ATTACHMENT 9.7

AREA WALK-BY CHECKLIST

IP3

Status: Y N U Area Walk-By Checklist (AWC) AWC-010Location: Bldg. IS Floor El. 15'-0" Room, Area¹ _____SWEL Components: SWEL1-030, 031**Instructions for Completing Checklist**

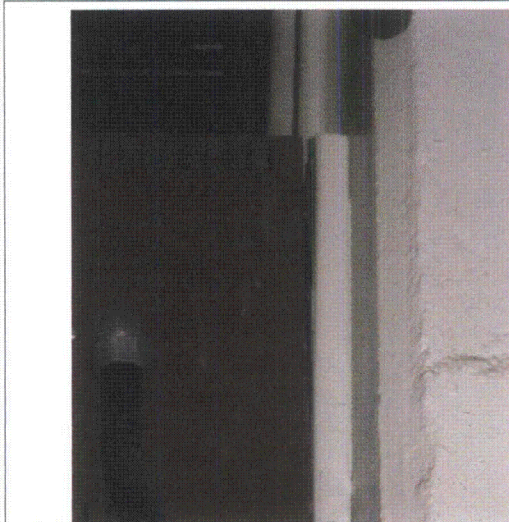
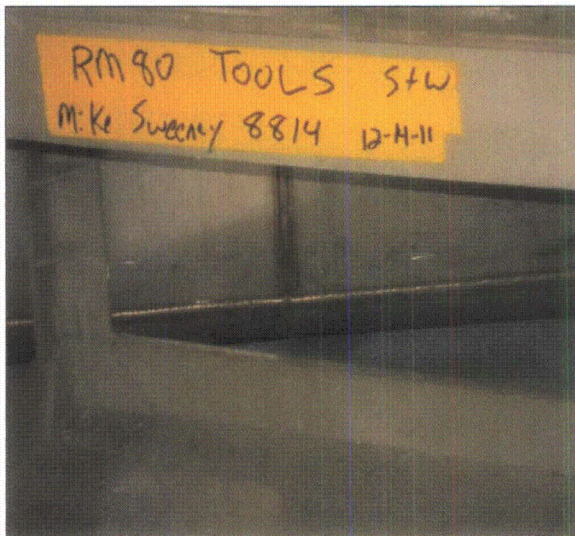
Note: Appendix R cabinet with gap at top behind back plate

Note: Unsecured cart

Note: Identification of unsecured cart

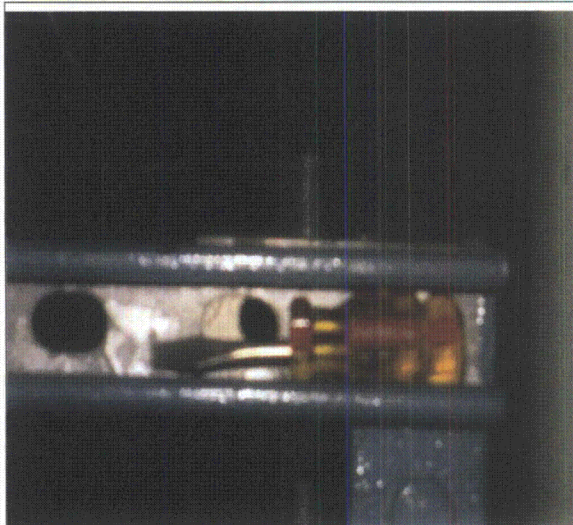
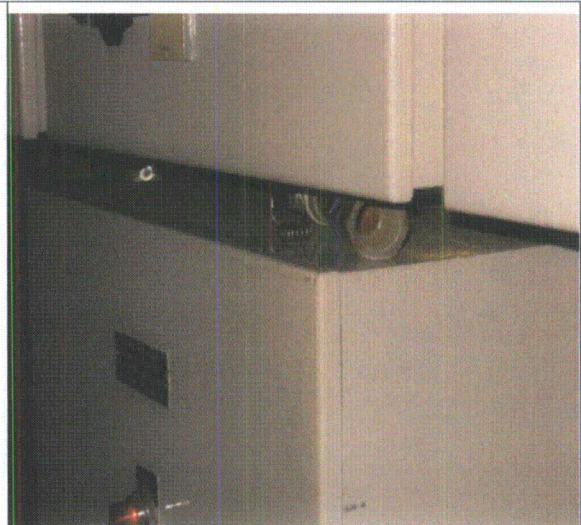
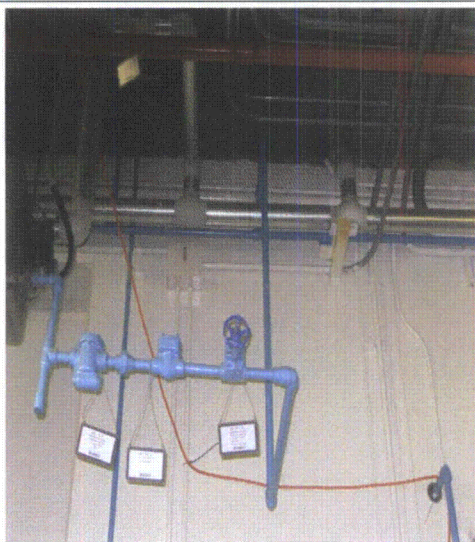
Note: Screw driver left on Unistrut

Note: Miscellaneous parts on top of panel

Note: Area heater UH334 piping not seismically supported

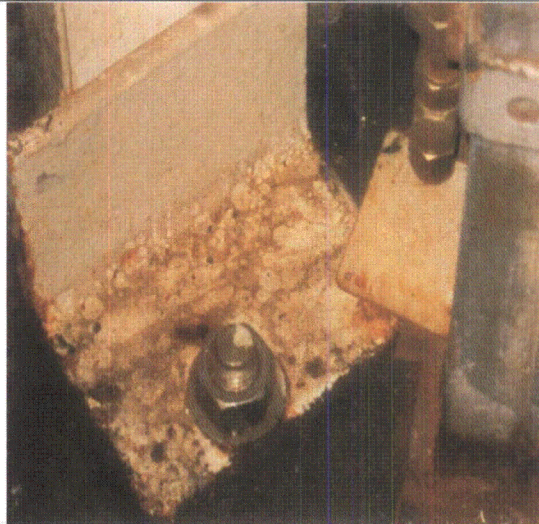
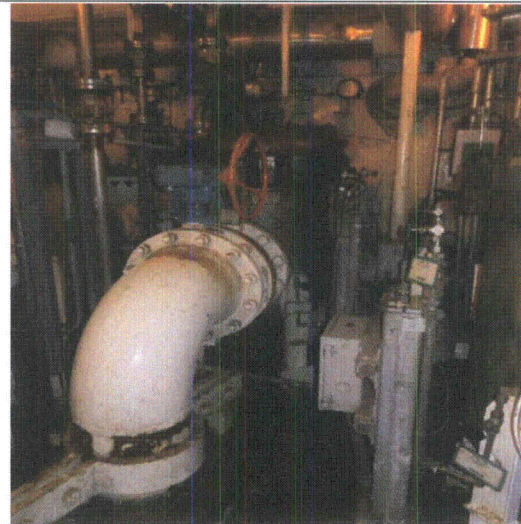
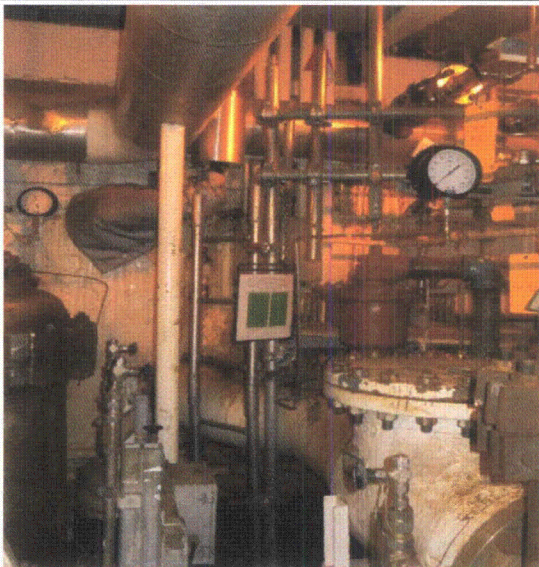
Note: Anchor bolt for strainer (stainless steel) with some corrosion of base angle.

Note: View of piping at strainer

Note: Scaffolding adjacent to strainers with green tag.

Note: Corrosion at the base of a Unistrut column

Nearby Unistruts for panels and stanchions for pipe supports show varying signs of advanced corrosion. CR-IP3-2012-03633 has been written to remedy the condition for the stanchions. EC-38453 was generated to repair DPIC-1111 and DPIC-1113 thru 1116 racks. EC-28998 was generated for the corroded IA supports.

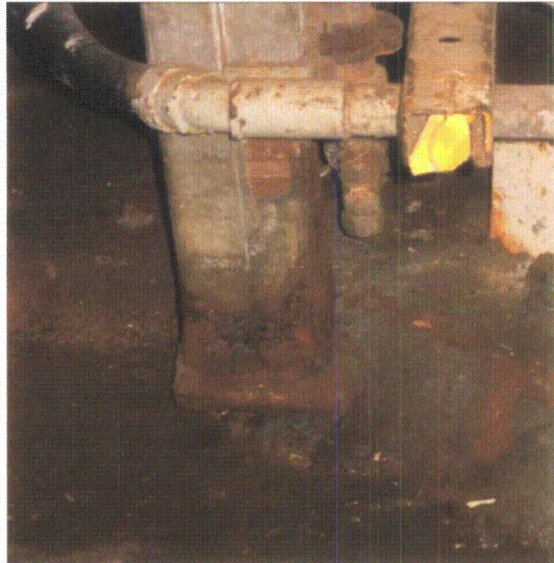
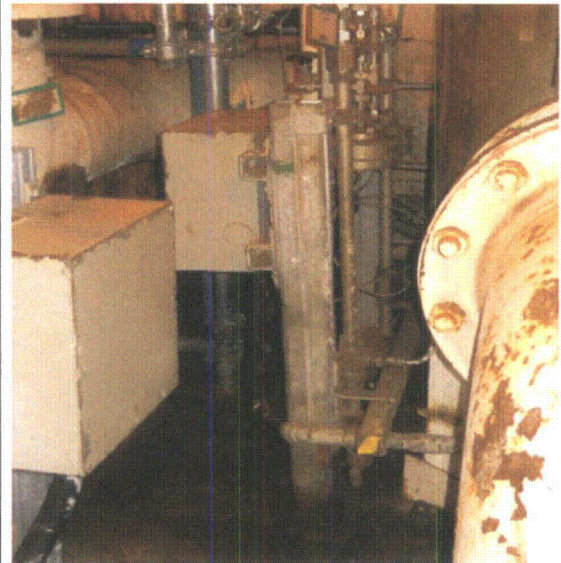
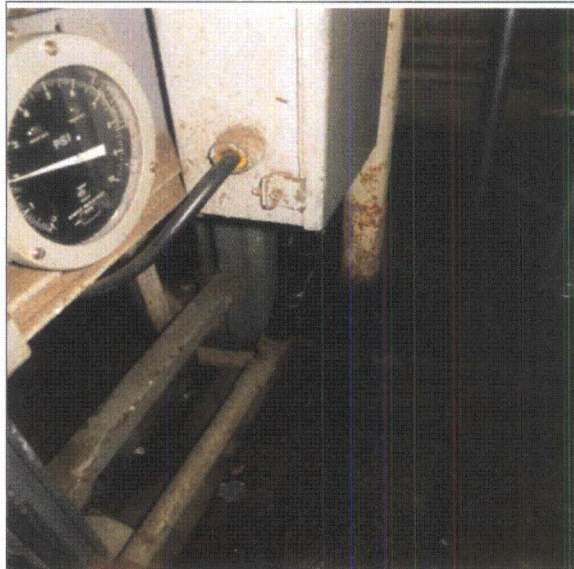
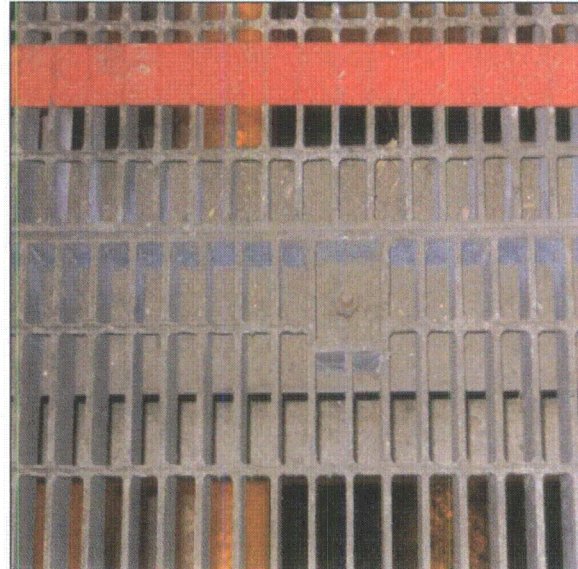
Note: Corrosion at the base of a Unistrut column

Note: Unistrut column which is beginning to tilt

Note: Pipe support stanchion showing considerable corrosion

Nearby Unistruts for panels and stanchions for pipe supports show varying signs of advanced corrosion. CR-IP3-2012-03633 has been written to remedy this condition. EC-38453 was generated for the DPIC racks. EC-28998 was generated for the IA supports.

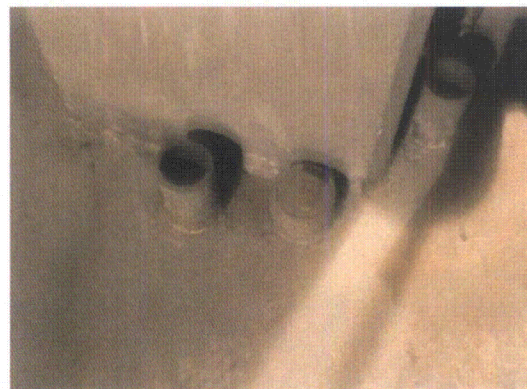
Note: unrestrained ladder by the north wall.

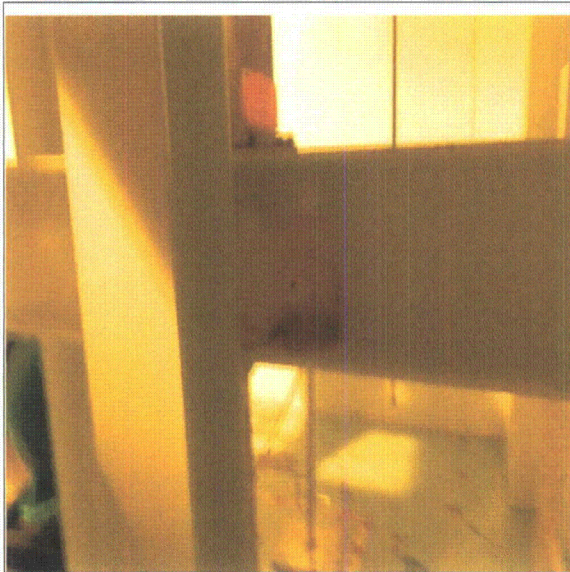
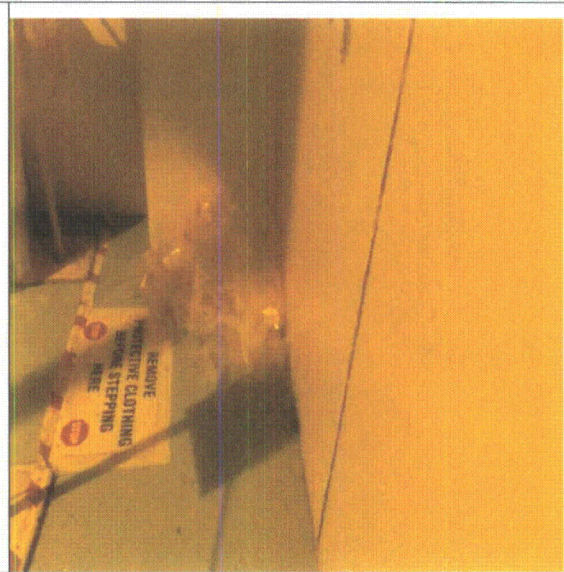
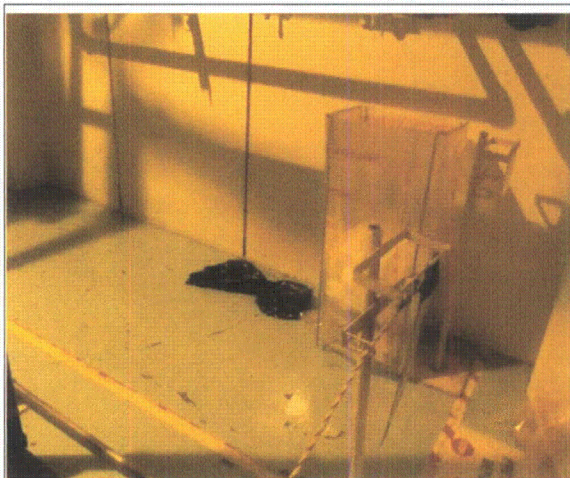
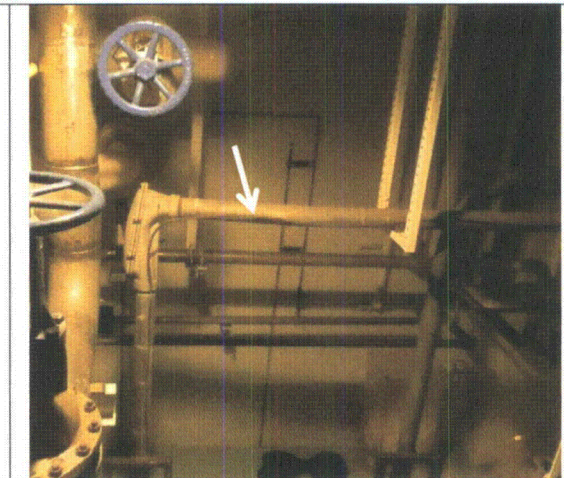
Note: bottle sitting on a beam

Note: waste bag on the floor

Note: waste bag on the floor

Note: bare wire attached to a conduit

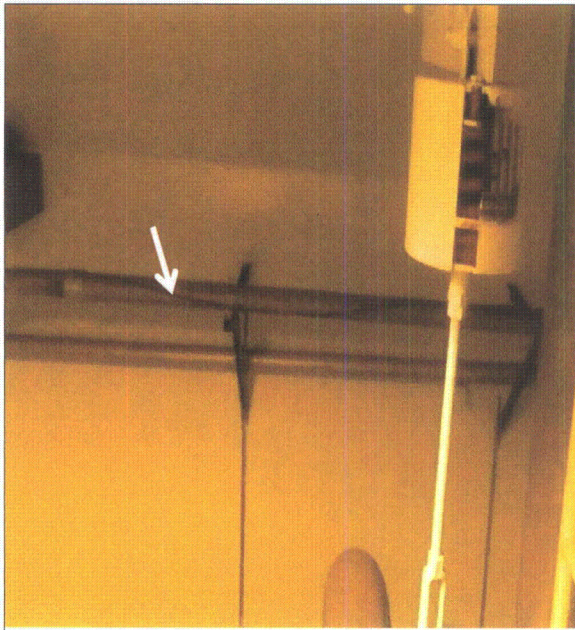
Note: bare wire attached to a conduit
